RE: Wellington Hotel
Site Plan Comments
192 Main Street
Wellington, Ontario

Please accept this letter as response to comments received in relation to the site plan approval comments, dated August 25, 2023.

Development Services Comments

DWG. TITLE
SITE PLAN

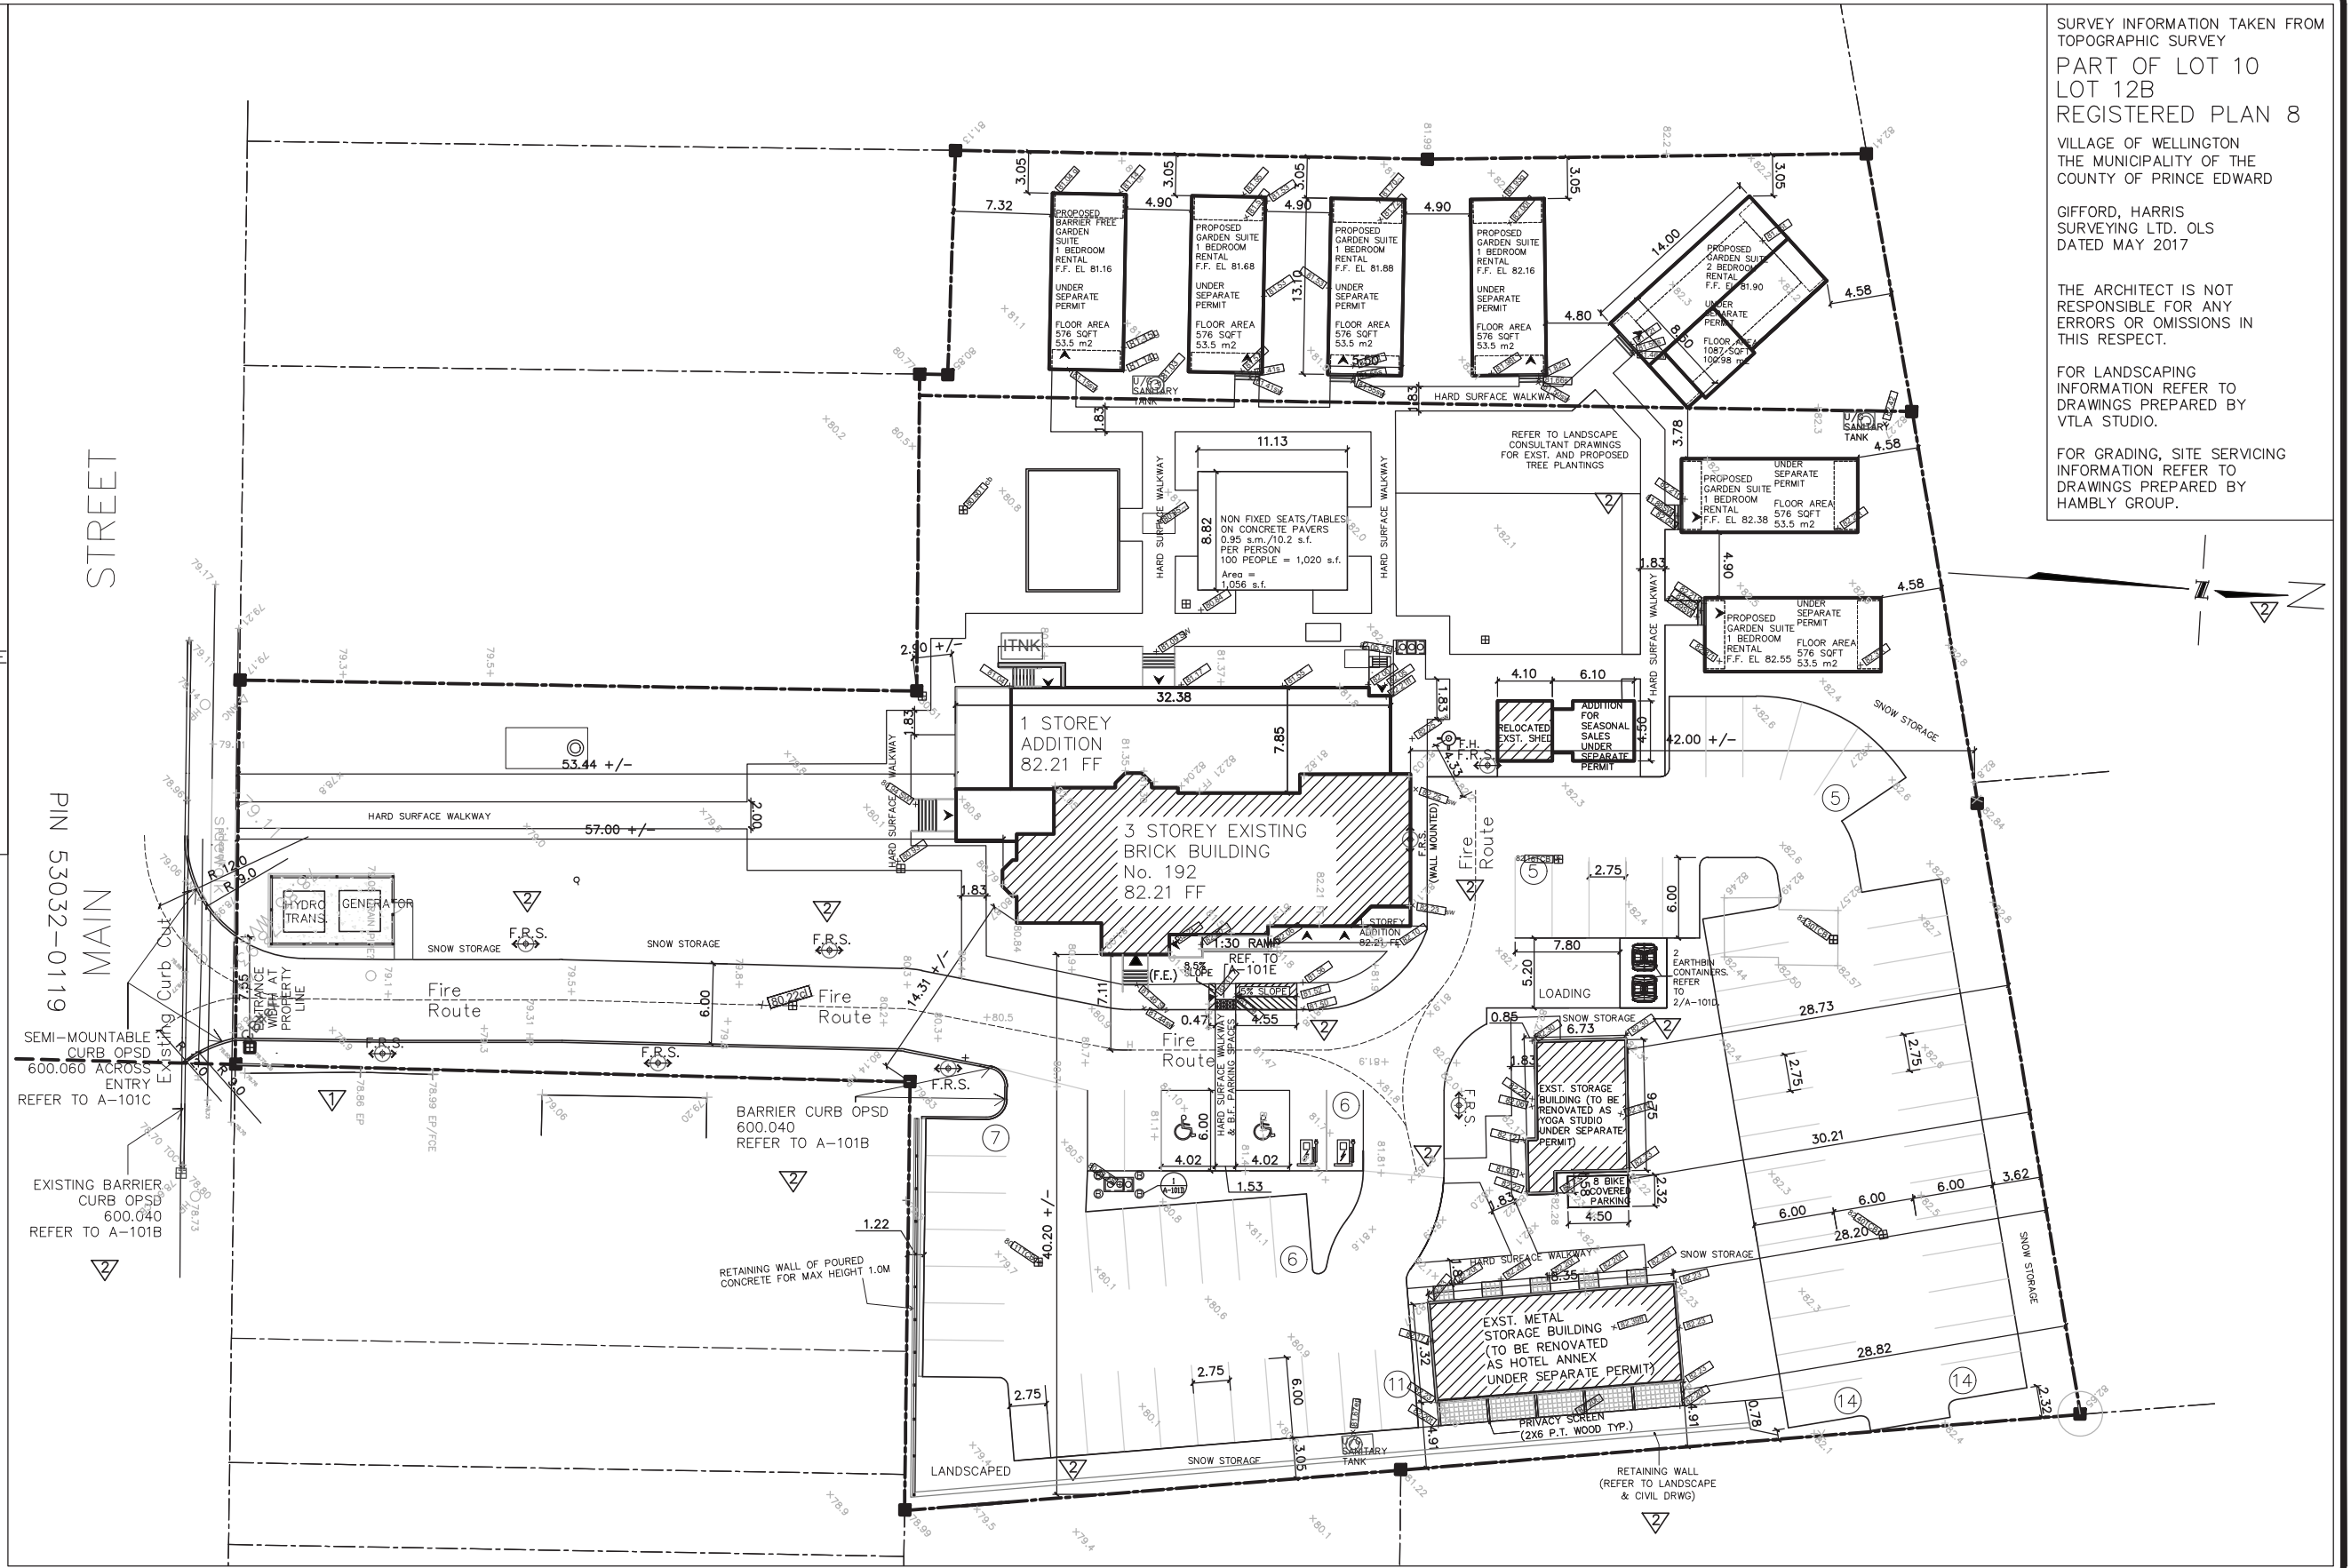
2. The drawing is still busy and difficult to follow. Please remove irrelevant information (i.e. grades and elevations, hydrants, manhole, etc).

11. There should be depressed curves provided between pedestrian walkways and paved areas as shown in the exert below. Please provide detail drawings for these depressed curves.

13. Please provide a detail for the intersection between the driveway and Main Street that shows left and right-hand turning radius'. It is unclear whether those entering from the east will need to traverse 186 Wellington Main Street to access the property.

Response: Refer to Site Plan Drawing A-100.

Response: Walkways slope down to RAP - no depressed curb detail required; VTLA to provide sloped walkway detail.

Response: Refer to detail of entrance curb radii intersection with Main Street curb; entrance from east side of driveway does not traverse the neighbouring property. Refer to detail 1/A-100.

A-101

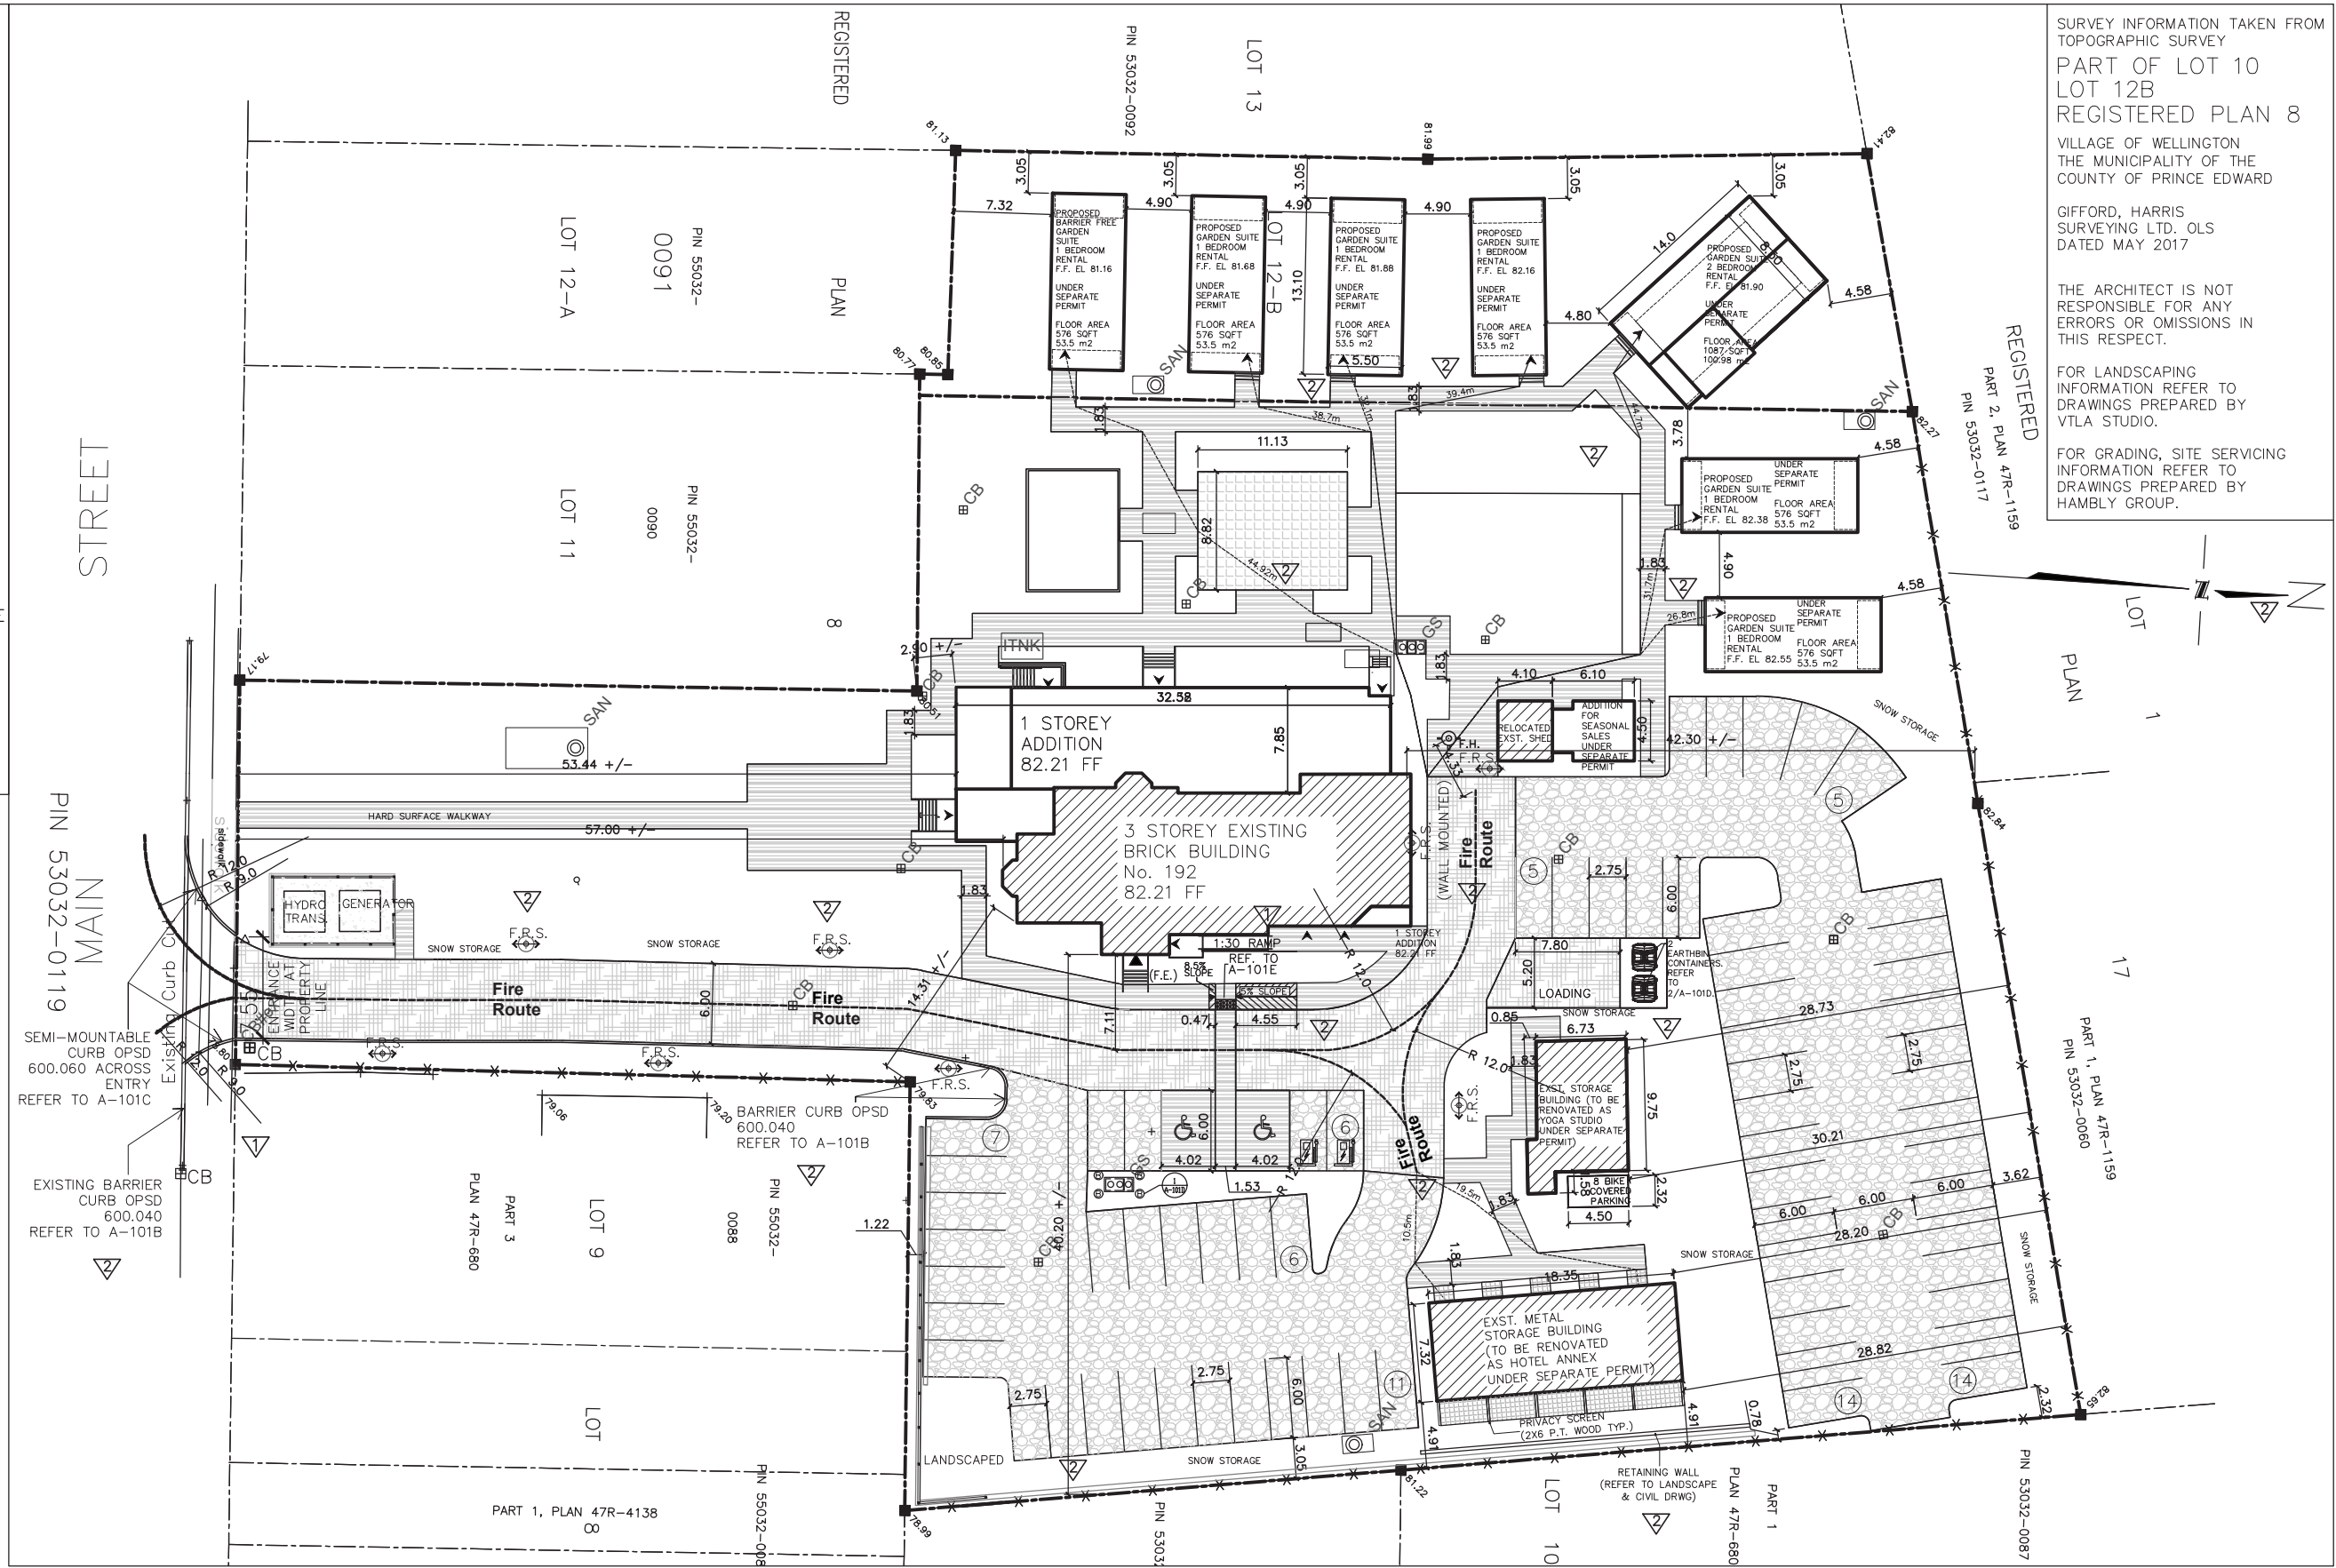
3. Please remove bubbles from Site Plan and use notes instead.

12. Bollard details provided in drawing A-1010; however, the location of bollards is not indicated on the site plan. Please update the site plan to indicate the location of bollards or remove this detail if it is not needed.

14. Will curbs be provided around the perimeter for all parking areas? If so, please provide this detail.

Revision clouds/bubbles removed. Refer to A-101, A-101A.

Response: Bollards are shown on site plan drawings A-101 and A-101A, near barrier-free parking spaces.

Response: Curbs are not provided around the entire perimeter for all parking areas; curb is shown along eastern side of the entrance drive - refer to A-100, A-101, A-101A. Refer to curb detail OPSD 600.040 on A-101B.
